ARMY AVIATION TEST BOARD FORT RUCKER ALA  
PRODUCT-IMPROVEMENT TEST OF IMPROVED DOOR LATCHES FOR OH-6A HEL--ETC(U)  
MAR 68

SUBJECT: Final Report of Test, "Product-Improvement Test of Improved Door Latches for OH-6A Helicopters,"  
USATECOM Project No. 4-6-0251-07.

Figure 1. Improved door latch  
for the OH-6A.

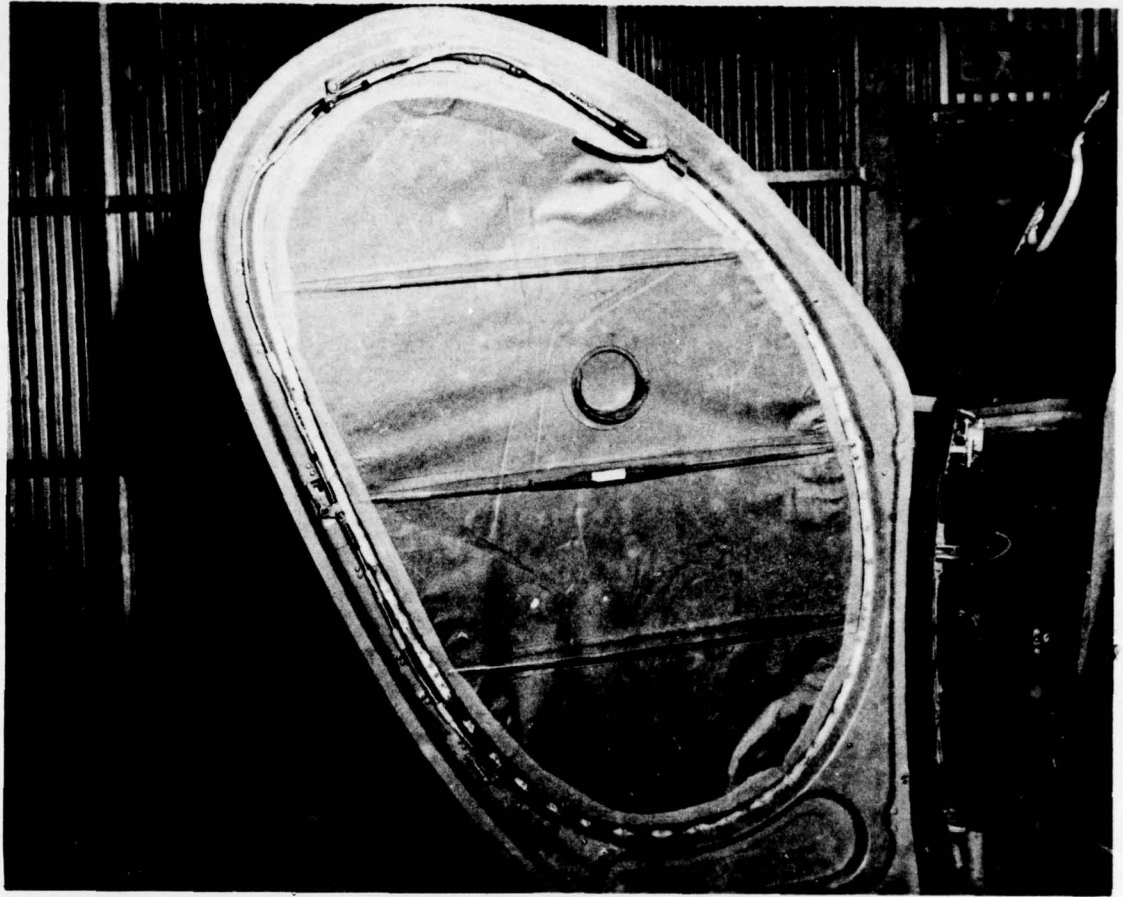
4. Description of Materiel. The test door latches (figure 1, inclosure) provide four adjustable lever latches constructed from material which is heavier than that originally used. The latch cable is

Figure 2. "Stop" (A) for inside  
handle and rubber  
dust boot (B).

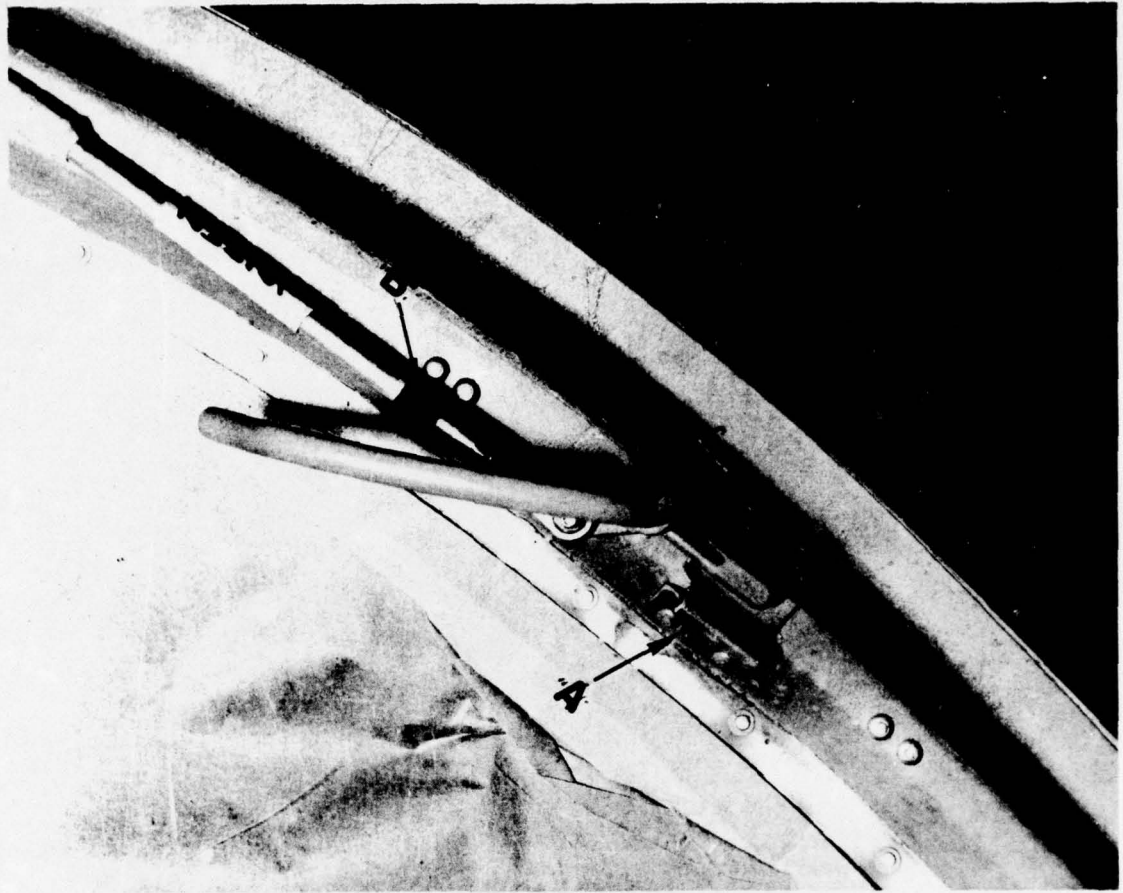
d. During installation of the door latches, the manufacturer's representative installed a "stop" for the inside handle (figure 2, item "A"). This "stop" prevented the handle from traveling past the center (open) position, thereby precluding overstressing of the cable.

e. The rubber dust boots on the ends of the conduit (figure 2, item "B") were not bonded in place and could be inadvertently displaced.

8. Recommendation. It is recommended that the improved door latch mechanism, modified to incorporate bonded dust boots and a "stop" for the inside handle, be installed on production aircraft doors.
